LBH Highways - Response

DATE:	14 April 2023	CONFIDENTIALITY:	Restricted
SUBJECT:	Berol Quarter (Berol Yard) – London Borough of Haringey Highway Response		
PROJECT:	70094918	AUTHOR:	Mark Cottray
CHECKED:	Sam Tearle	APPROVED:	Mark Cottray

WSP UK Ltd was appointed by the Applicants to provide transport design and planning advice to support the planning application. The purpose of this Technical Note is to respond to comments from the London Borough of Haringey (LBH) Highways, issued on 21st March 2023.

Figure 1: Josta 2-Tier Cycle Rack (L) Vs Standard 2-Tier Cycle Rack (R)

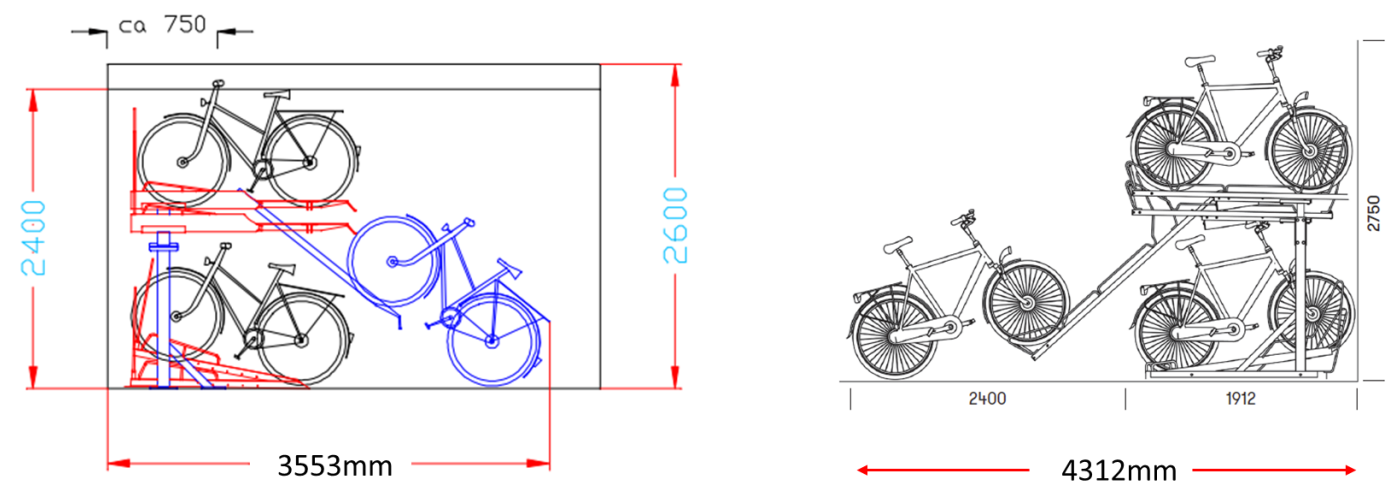
The proposal includes cycle parking provision for 48 long-stay and 30 short-stay cycle parking spaces for Berol House and 380 long-stay plus 24 short-stay spaces for 2 Berol Yard. The layout of cycle parking does not meet LCDS standards for aisle widths adjacent to two-tiered cycle parking. Revised submission of detailed cycle parking layout with dimensioned plans that complies with LCDS, are required.

Furthermore, the Applicant wishes to highlight that the proposals assume the use of a Josta 2-tier cycle racks (or equivalent), which are considered an innovative solution to provide high quality cycle parking for sites with limited space. **Figure 1** below illustrates:

- The Josta 2-tier cycle rack that shows the rear of the bike extends out 3553mm from the wall when the rack is pulled down; and
- Another with a more standard 2-tier system that shows the rear of the bike extends out 4312mm from the wall when the rack is pulled down.

The image illustrates the advantages of the Josta 2-tier cycle rack system with its compact footprint, which is achieved by having the top rack sit higher off the floor than other more standard systems and hence needs less operating space than other systems. It highlights that not all 2-tier systems are the same and some will need a wider walkway.

Figure 2: Extract of images from LBH Highways

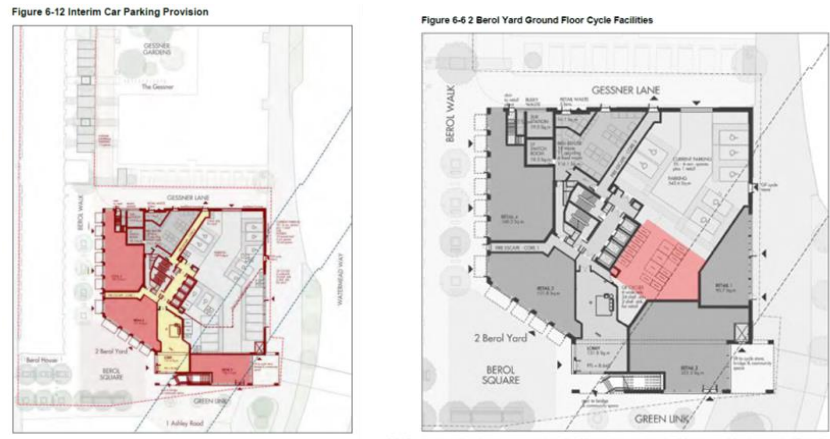
Clarification is required regarding the overlaps in layout of interim retained 30 car parking in Fig.6.12, the cycle parking illustrate at Figure 6.6 and the vehicular swept path for a refuse vehicle, below.

The Applicant confirms that the bottom right image shows vehicle access at the northern end of the site boundary and that there is no overlap.
